**PLANNING COMMISSION
SITE PLAN COMPATIBILITY WAIVER REQUEST REVIEW SHEET**

CASE: SP-2012-0122C

PROJECT NAME: IBC Bank Mueller View

SITE PLAN

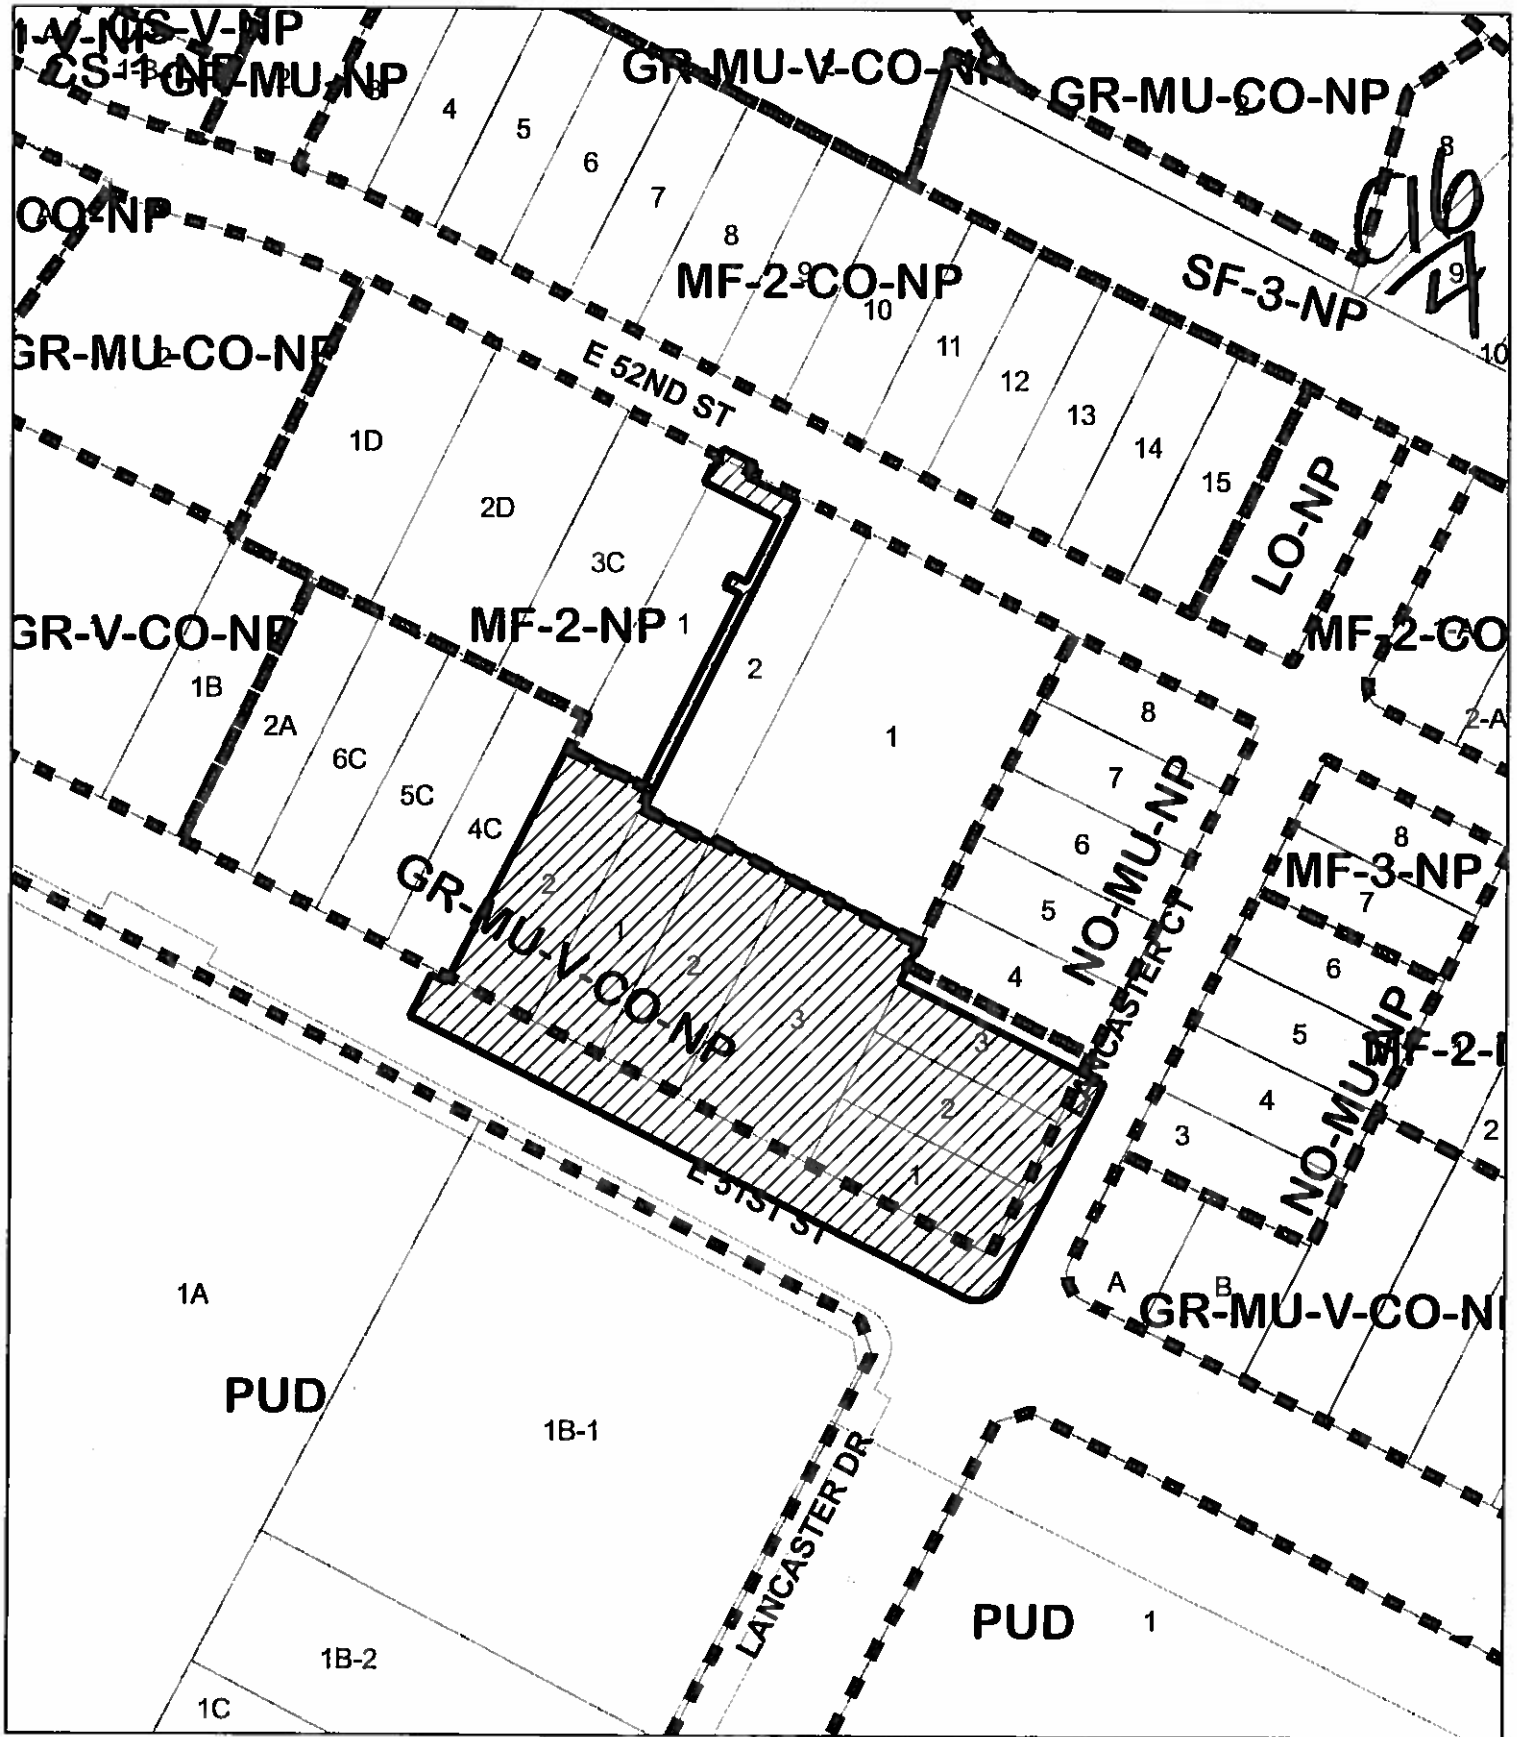
The applicant requests a waiver from a 25-foot to a 9.91-foot compatibility setback for a driveway. The site plan is adjacent to a single-family use in NO-MU-NP zoning district. The proposed driveway varies in setback from 20.68 feet to 9.91 feet at the rear corner of the NO-MU-NP zoned property.

Staff recommends approval of the waiver from LDC Section 25-2-1067(G) to reduce the Compatibility driveway setback requirement from 25 feet to 9.91 feet from adjacent NO-MU-NP zoned property used as single family. The adjacent single-family house is on the north side of its driveway. Therefore, the proposed driveway will be located next to the single-family driveway, with a 6-foot wooden fence in between the two driveways for additional buffering and screening.
